Service Note		
Product	Description:	Service note no.
TC2290	Fuses On TC2290 Main Board:	706 10 T066

IMPORTANT: When having 2290s with s.no. lower than 512020 for repair or service please make this correction.

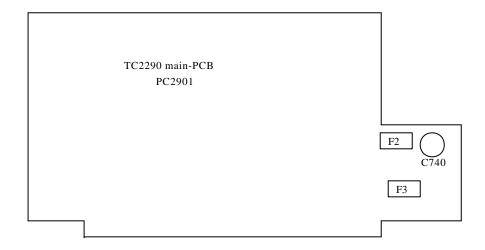
In order to avoid the two secondary fuses F2 and F3 to blow when extreme high tension accrues on the power network, please replace these fuses with a 400mAT type. The fuses are placed just beside the transformer on the main board.
